CHAPTER 10. SUPPLEMENTAL ANALYSIS OF THE 2023 DANA RESERVE SPECIFIC PLAN

10.2 2023 DANA RESERVE SPECIFIC PLAN REVISIONS

10.2.2 Proposed Revisions to the Dana Reserve Specific Plan

Figure 10-1a. 2021 DRSP Public Roadways.

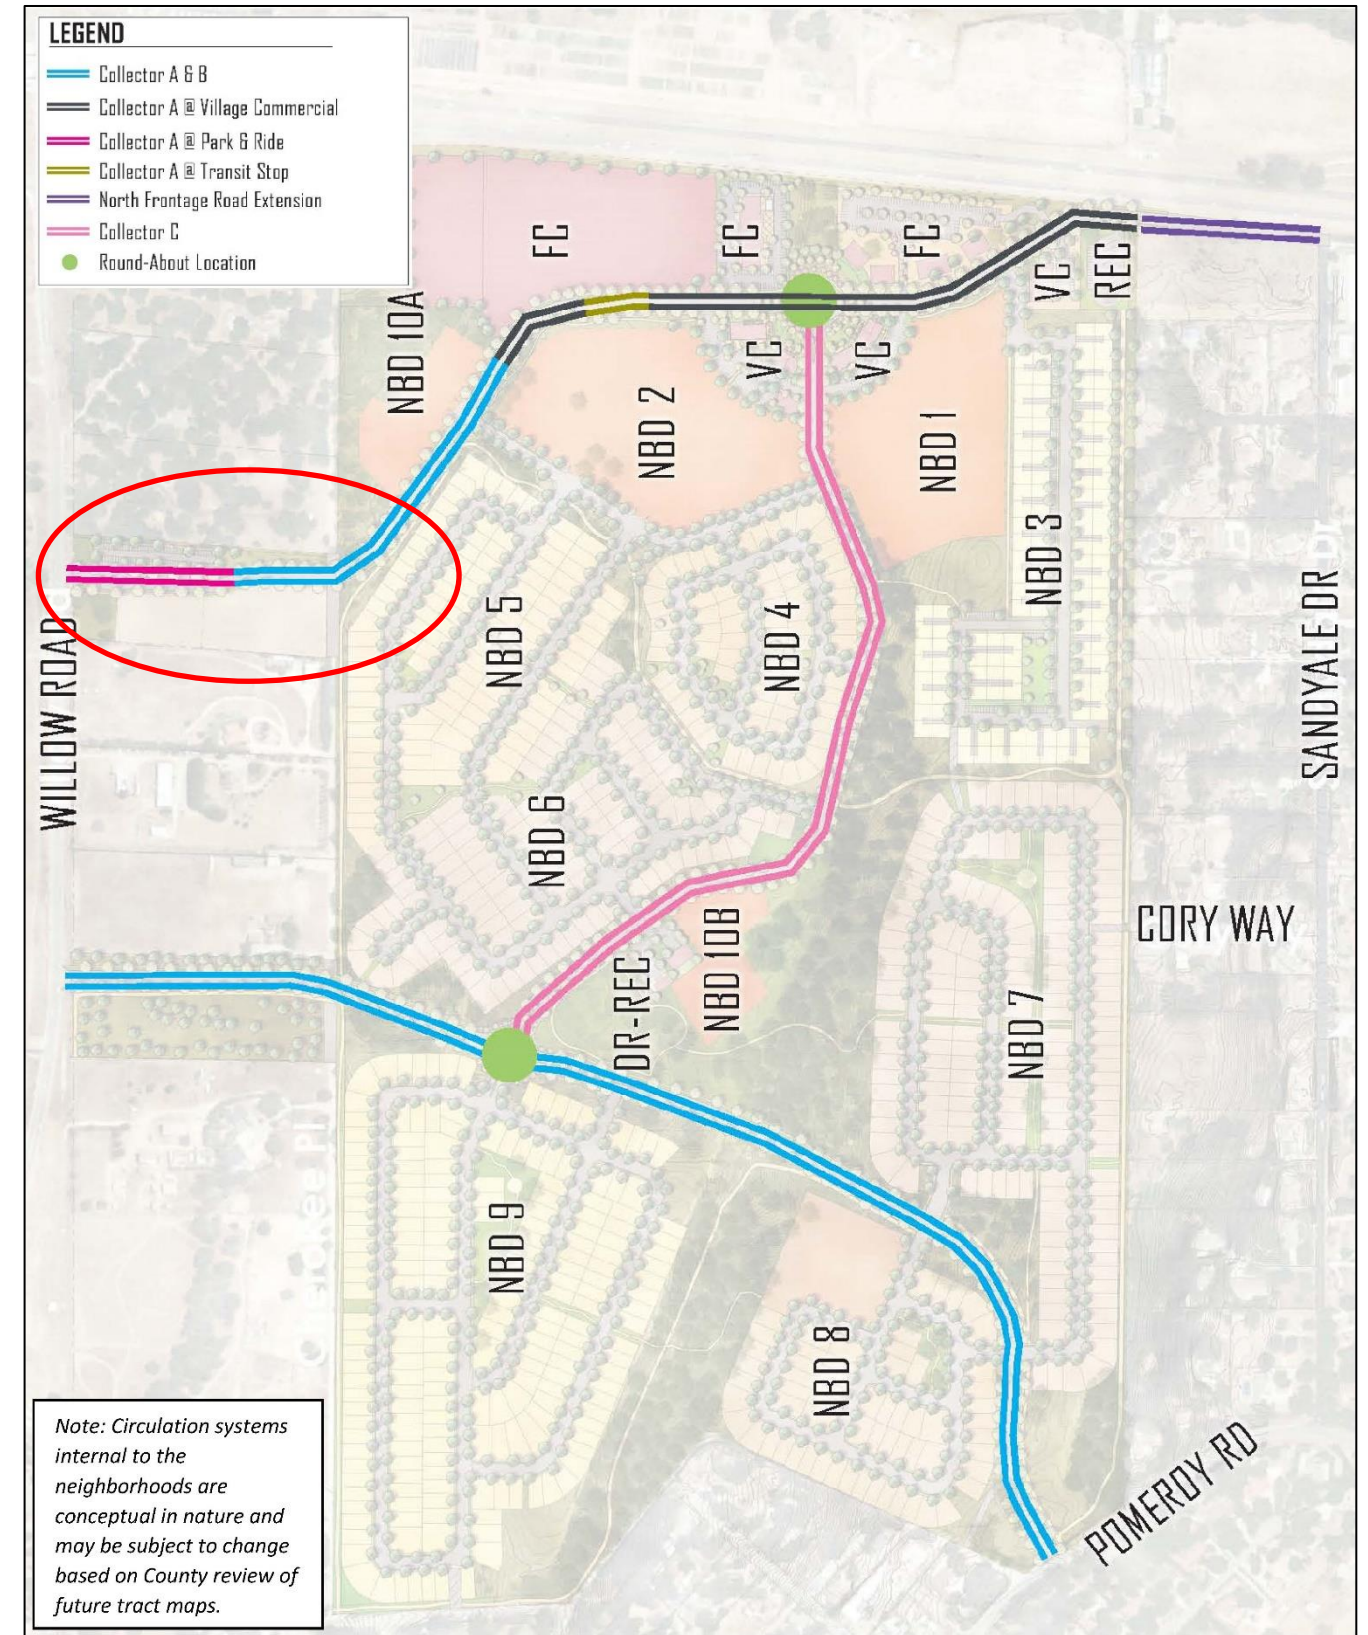
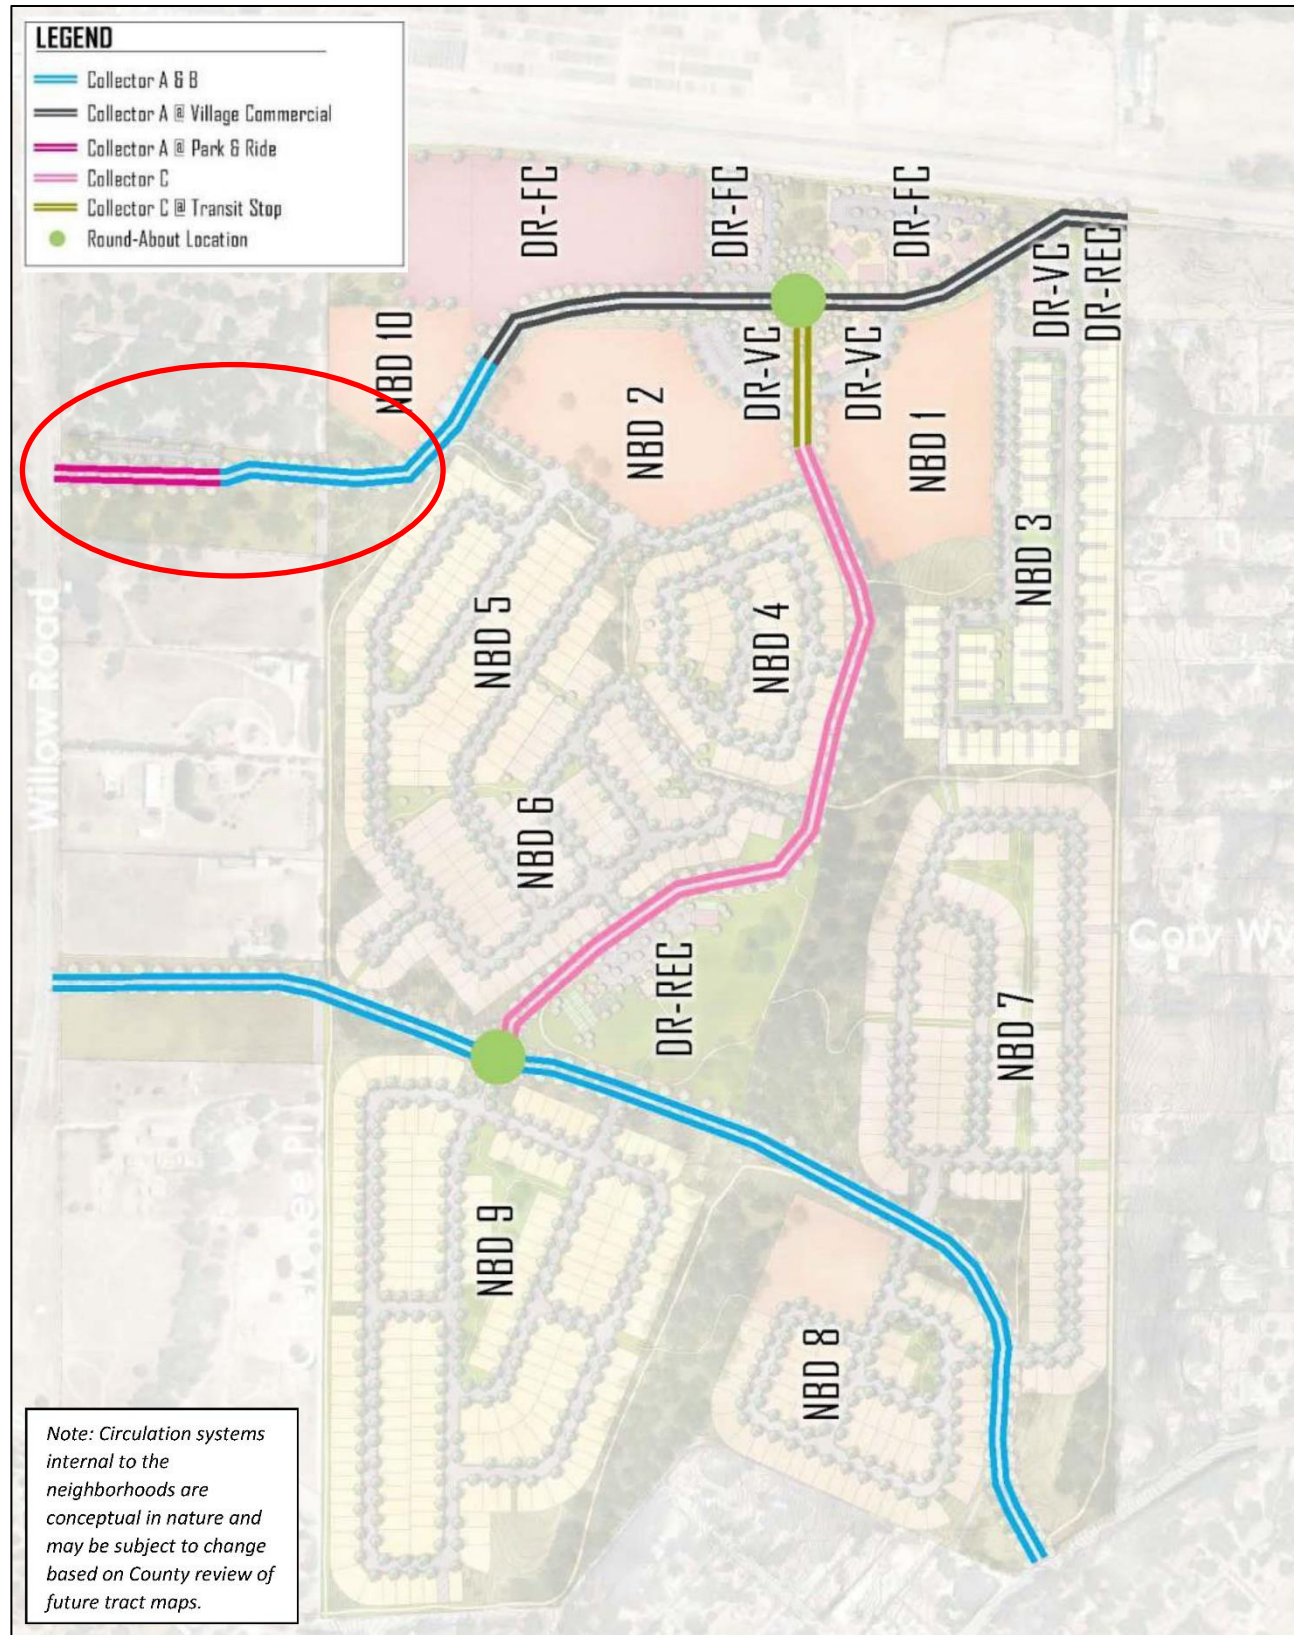
The applicant proposes to relocate Collector A from Assessor's Parcel Number (APN) 091-301-030 to APN 091-301-029 (Figures 10-1a and 10-1b). The Draft EIR determined that the development of Collector A on APN 091-301-030, in conjunction with other on-site development, would result in significant impacts to the 78.3 acres of on-site coast live oak woodland and would result in the removal of approximately 96% of this sensitive natural community. The proposed relocation of Collector A one parcel to the west would avoid removal of 200 native oak trees (approximately 7.68 acres or 9.8% of on-site woodland area).

This revision also clarifies that there will be a traffic signal at Collector A and Willow Road and include new public transportation stops north of the roundabout on Collector A and two stops at the park and ride lot along Collector A.

Figure 10-2a. 2021 DRSP Concept Master Plan.

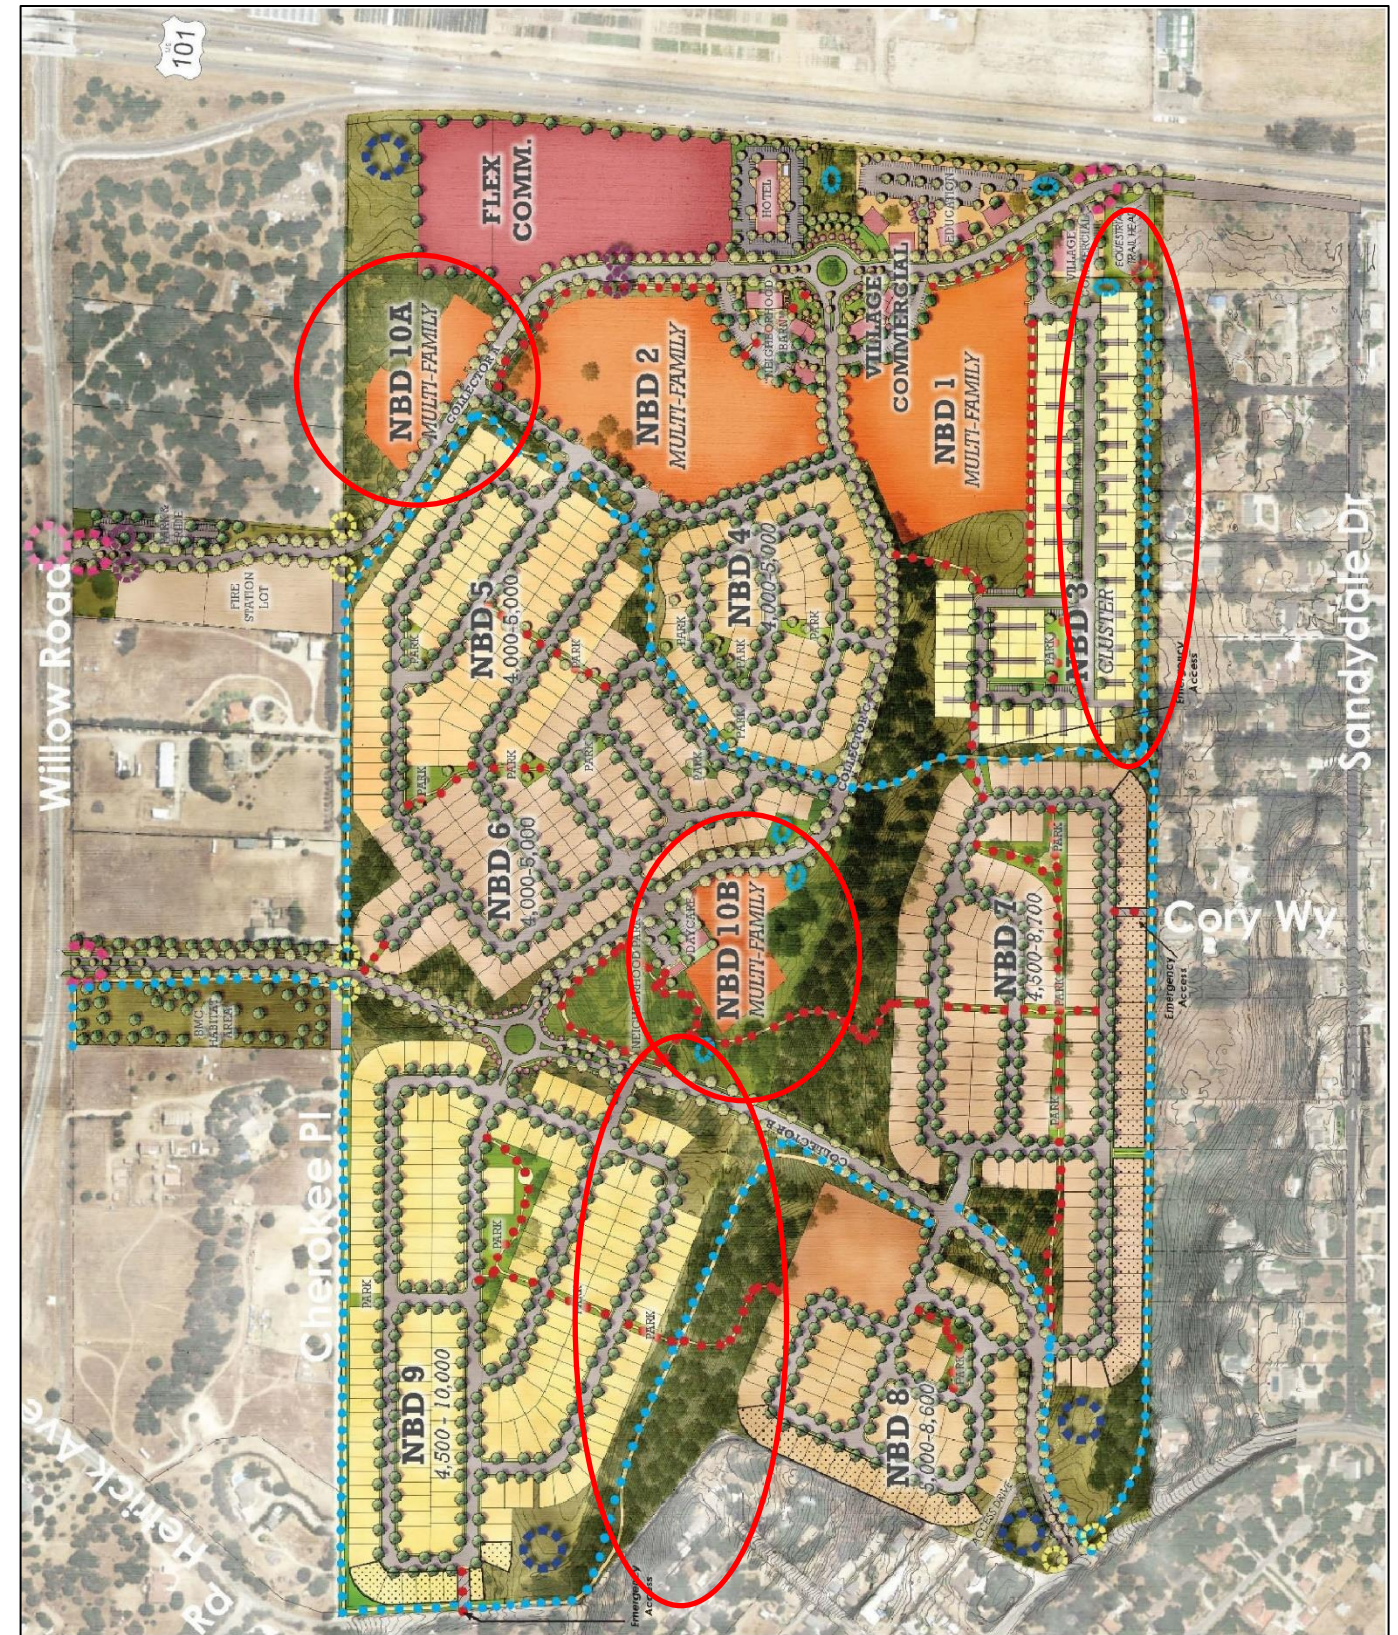
The applicant proposes to shift NBD 3 away from the southern property line (Figures 10-2a and 10-2b). Other revisions in the document restrict structures in NBDs 7, 8, and 9 to single-story where located adjacent to existing single-family residences. However, due to the smaller lot sizes of NBD 3, this restriction is not feasible. Instead, the applicant has shifted the entire NBD 3 cluster to the north, which adds an additional 45-foot buffer between NBD 3 and the residences to the south (from 65 feet to 110

NBD 9 has also been shifted off the ridge with the oak woodland canopy (see Figures 10-2a and 10-2b). This was accomplished by reducing the number of parcels in this neighborhood and shifting the southern segment of the neighborhood to the north slightly. The reorientation of NBD 9 would avoid the removal of 69 native oak trees adjacent to the proposed open space.

NBD 10 has been partially relocated (see Figures 10-2a and 10-2b). The Draft EIR version of the DRSP included all of NBD 10 adjacent to the northern property line, west of the Flex Commercial (DR-FC) land use area. The Draft EIR determined that the development of this neighborhood would result in significant impacts to oak woodlands. Alternative 1 of the Draft EIR relocated NBD 10 from the northeastern portion of the project site to the central portion of the project site adjacent to the eastern side of the proposed public neighborhood park. As a result, the proposed public park would have been reduced to 6 acres in size. However, while the Alternative 1 relocation would have conserved an additional 4 acres of oak woodland habitat in the northeastern portion of the project site, it would have resulted in the removal of older and higher-quality trees, though in a lesser quantity. The proposed revision would split NBD 10 between the Draft EIR location and the Alternative 1 location. This configuration would avoid removal of 186 native oak trees. This revision was made in response to community concerns related to oak tree removal.
